ADDENDUM #3

PROJECT: Rapid Valley Elementary School Addition and Remodel
DATE: March 16, 2026
BID DATE: March 19, 2026 at 2:00pm MST

PROJECT ADDENDUM NO. 03

ADDENDUM NO. 3 - MECHANICAL

100% CONSTRUCTION DOCUMENTS
DATE: 03.02.2026 SHEET NO:
PROJECT NO: S401

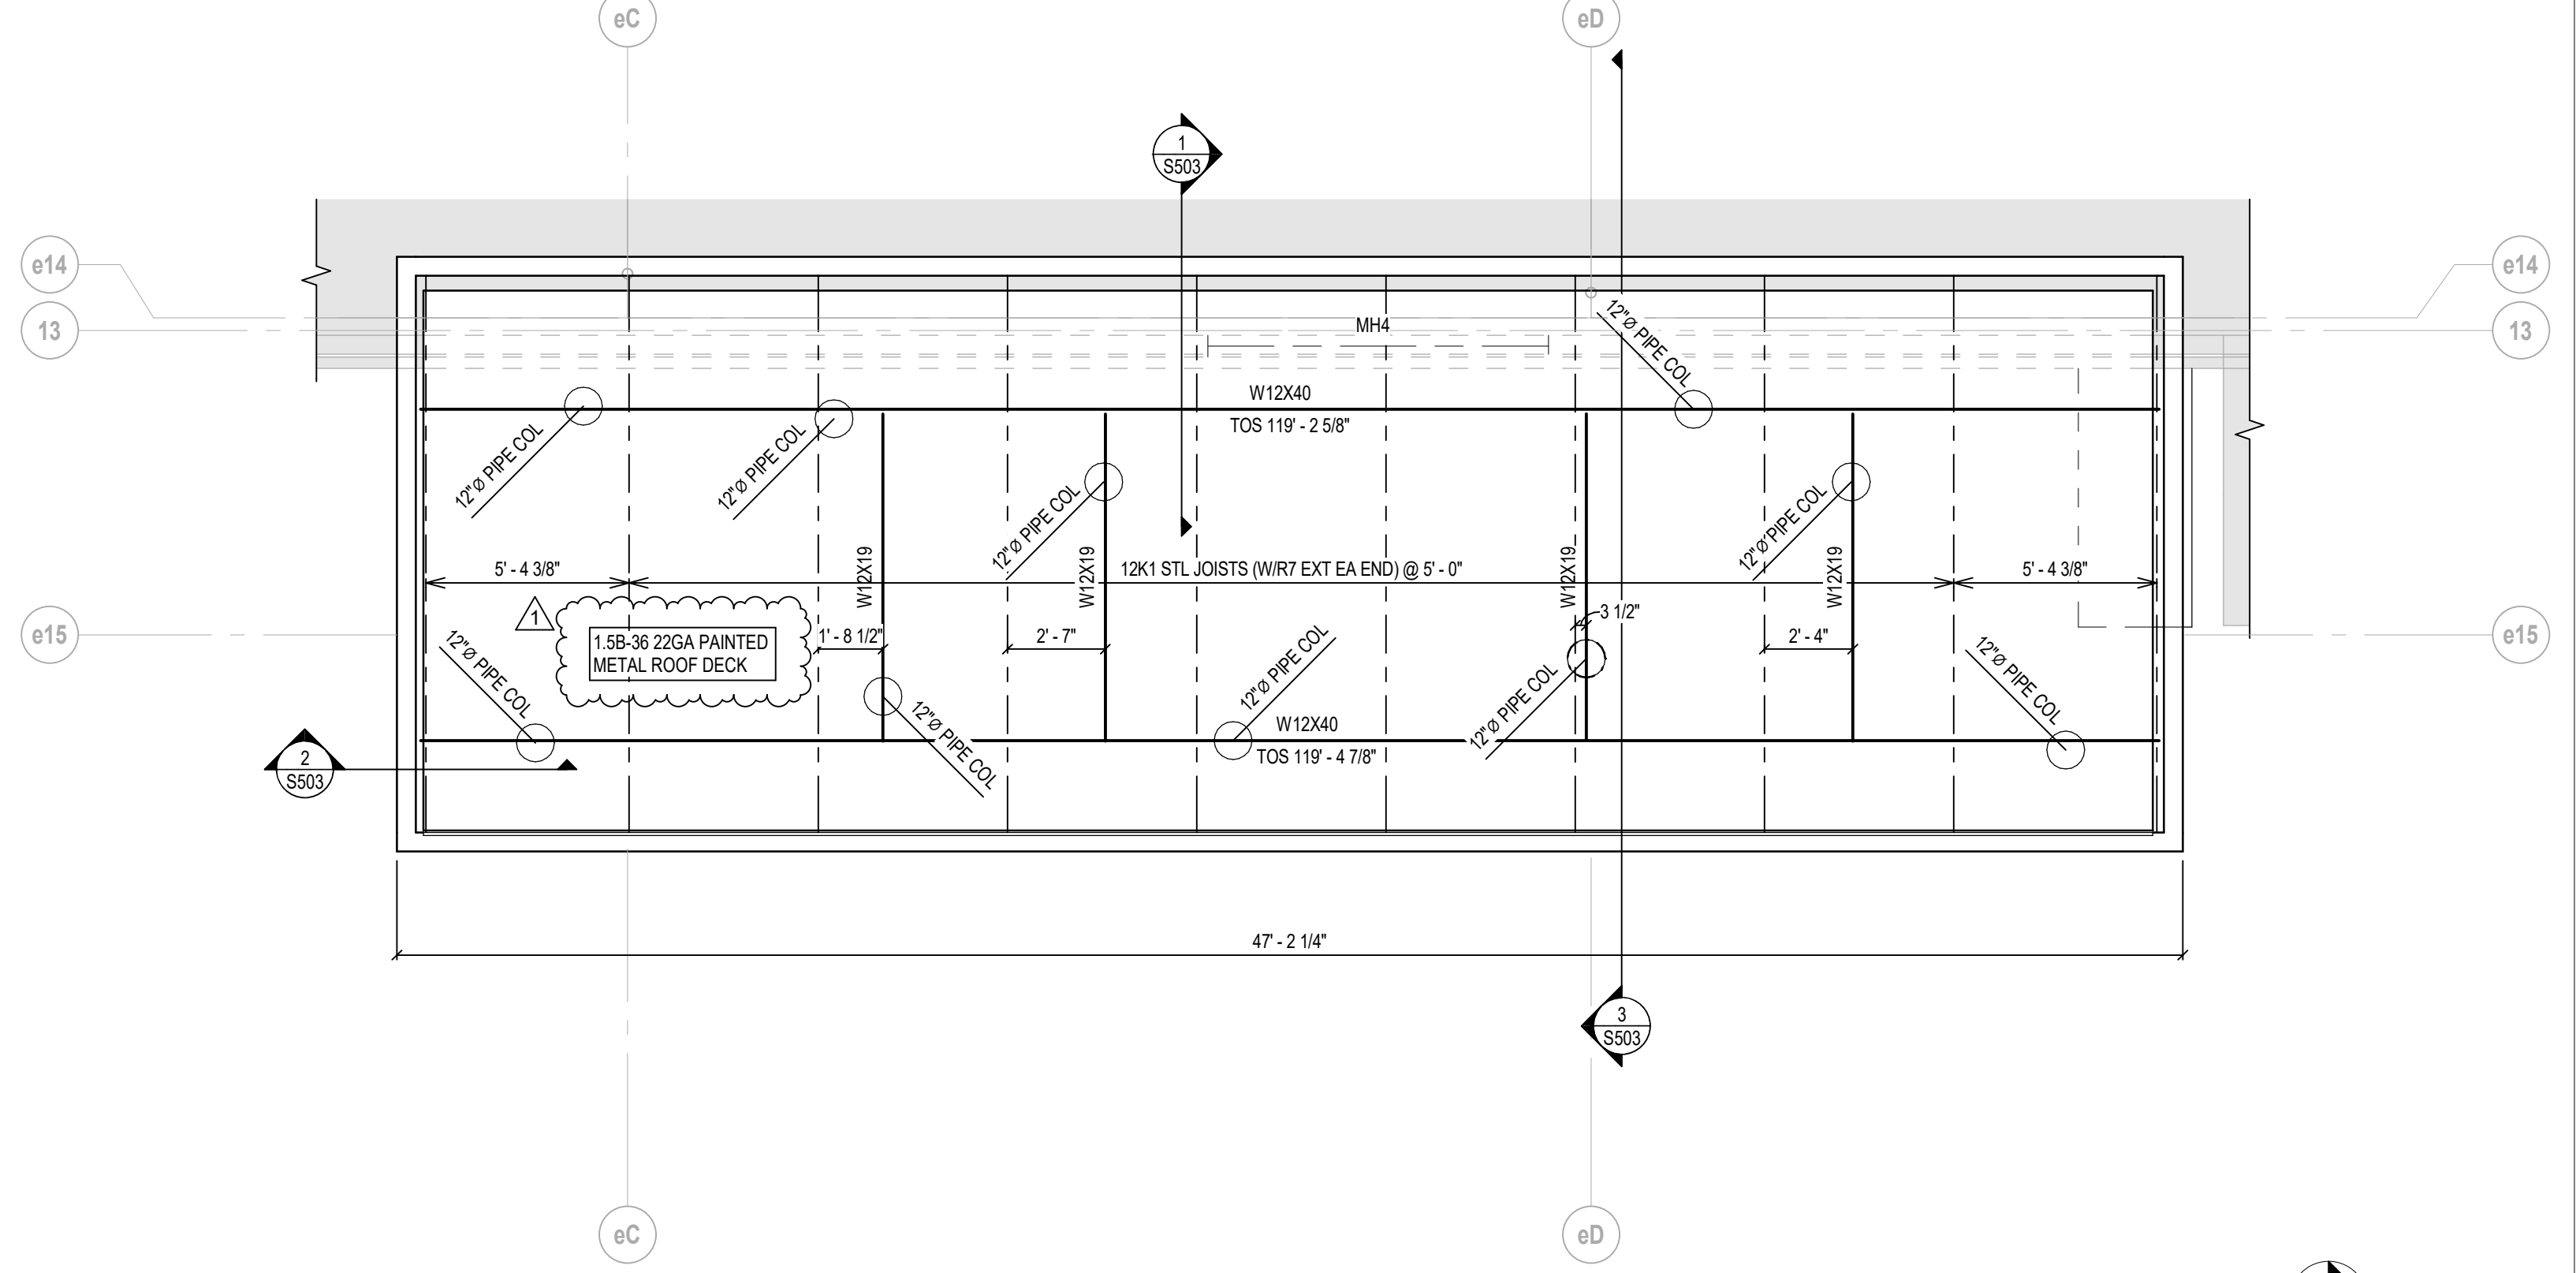
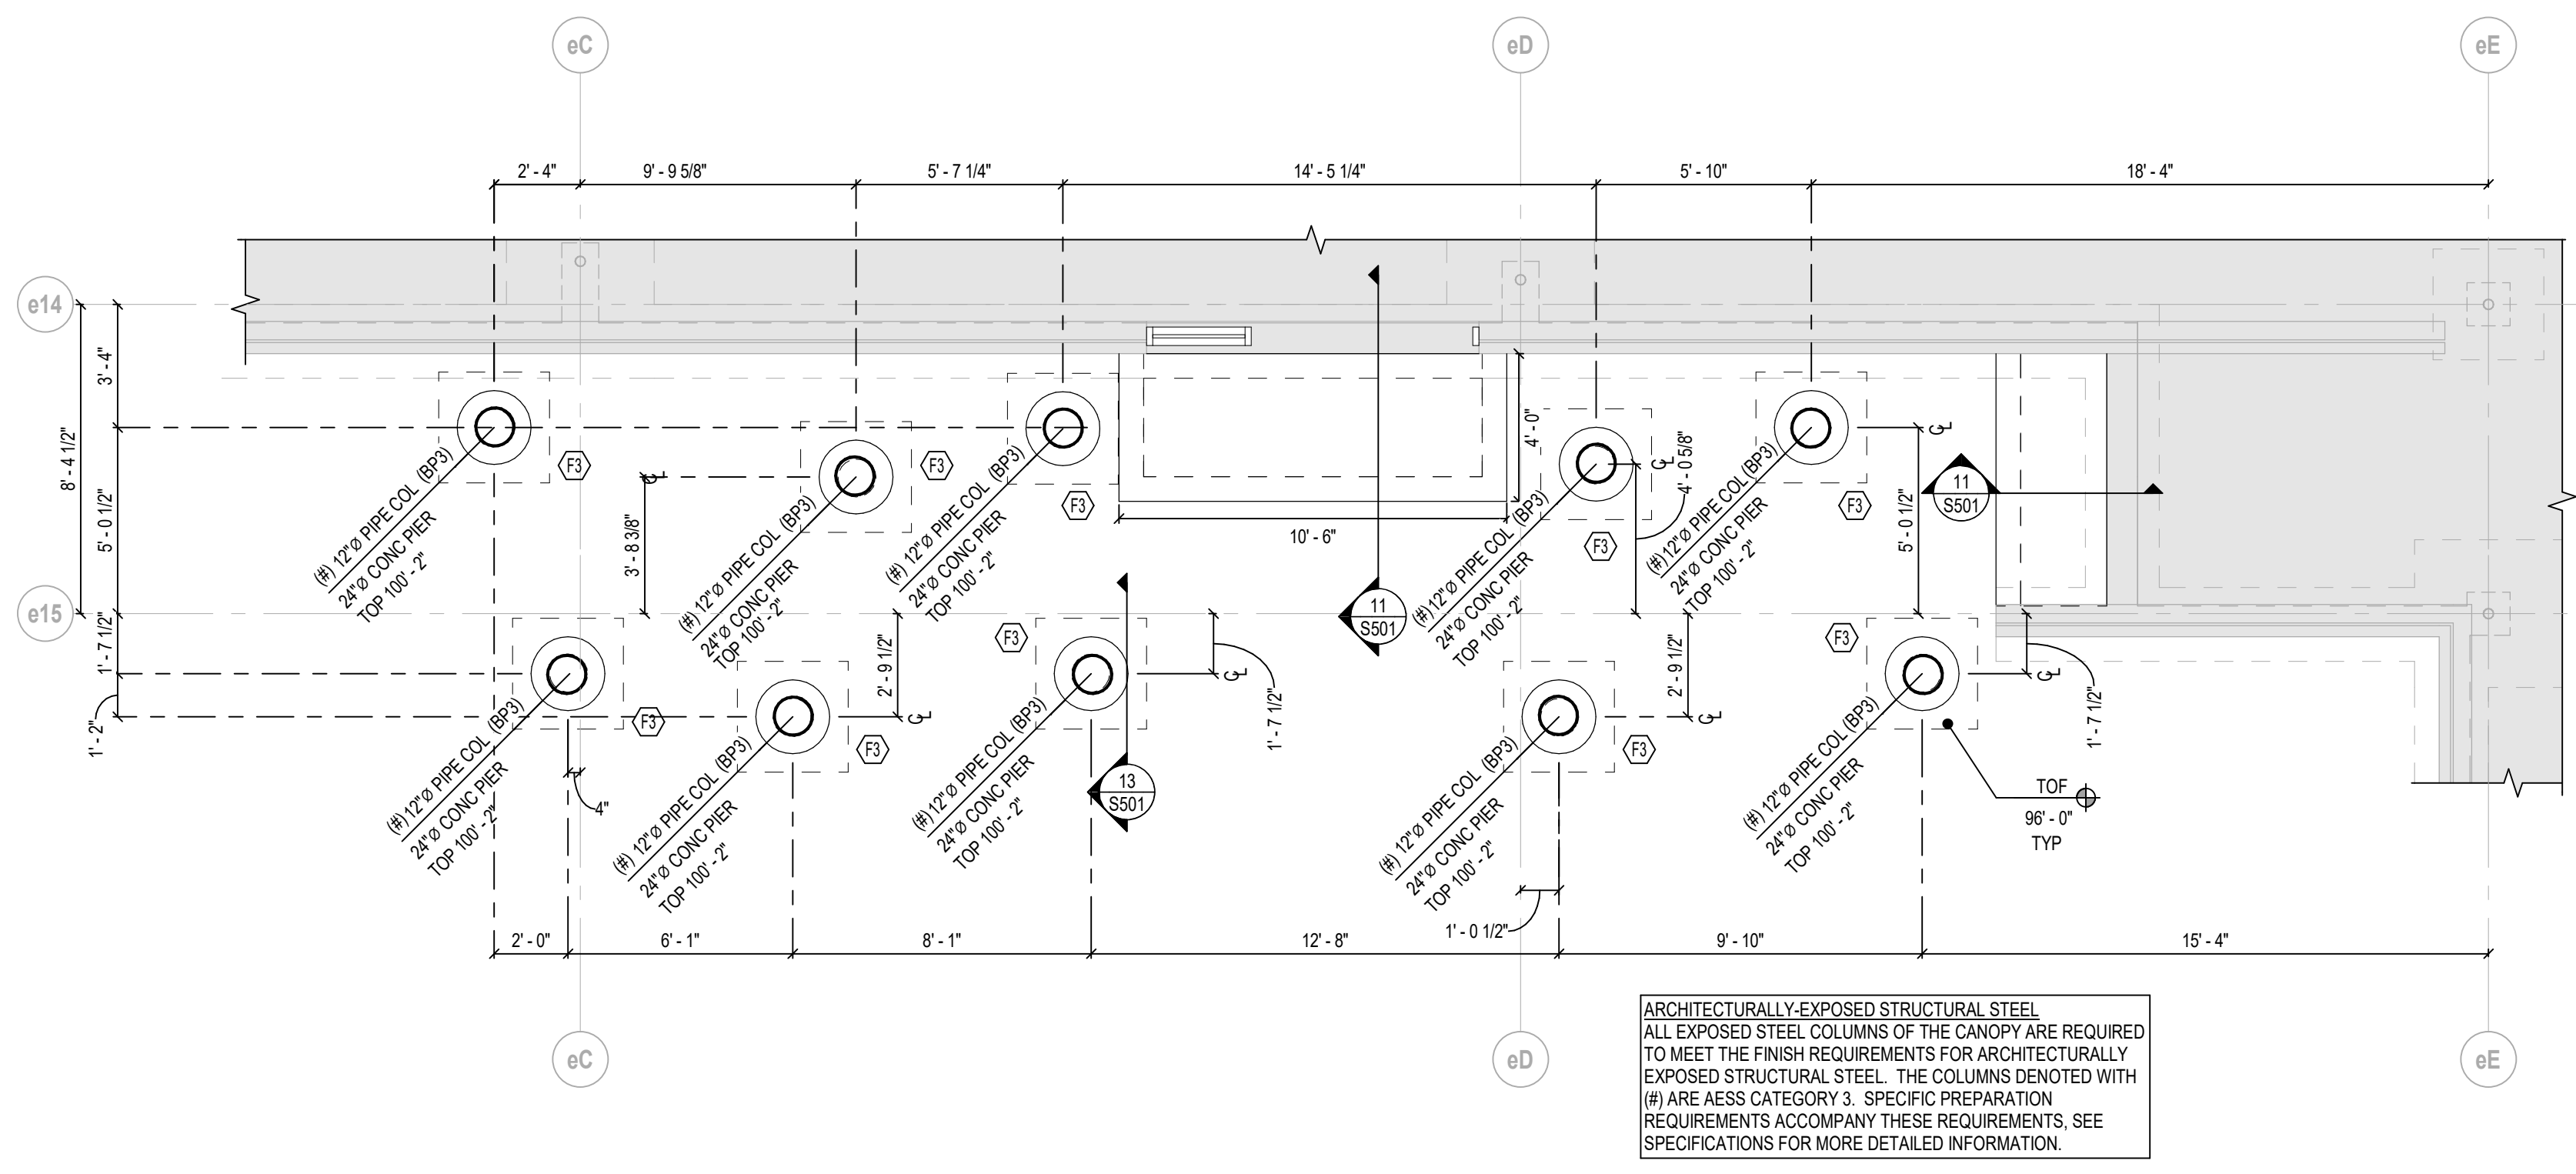
- ◆ SHEET S401
 - i. Canopy Roof Framing Plan – West, steel roof decking note was added.
 - ii. Canopy Fnd Plan – SE, square concrete piers were revised to be round piers.
- ◆ SHEET S501
 - i. Detail 14 was updated for the round piers.
 - ii. Detail 13 & 14 – Note added to chamfer top edge of pier.
